**IMPERIAL METALS CORPORATION**

**GEOTECHNICAL REVIEW, DRAINAGE ASPECTS**

**MAIN EMBANKMENT DAM**

**TAILINGS STORAGE FACILITY**

**Photo 19.** Exposure in base of Reclaim Barge Channel, East Side, Near South end.

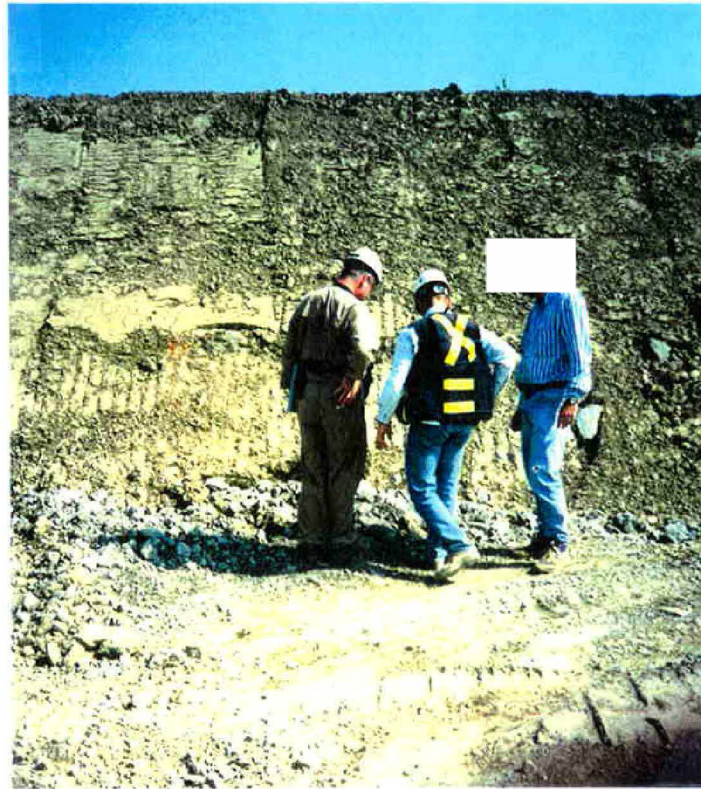
The till cap appears to have been completely removed locally in the base of the Reclaim Barge Channel (Ref. 9.8 and Photo 19, Appendix I). It was also recommended that these local areas be checked and sealed, as required. Similarly the local area, (probably a former stream bed) at the upstream edge of the Basin Liner. (Photo 17 in Appendix I).
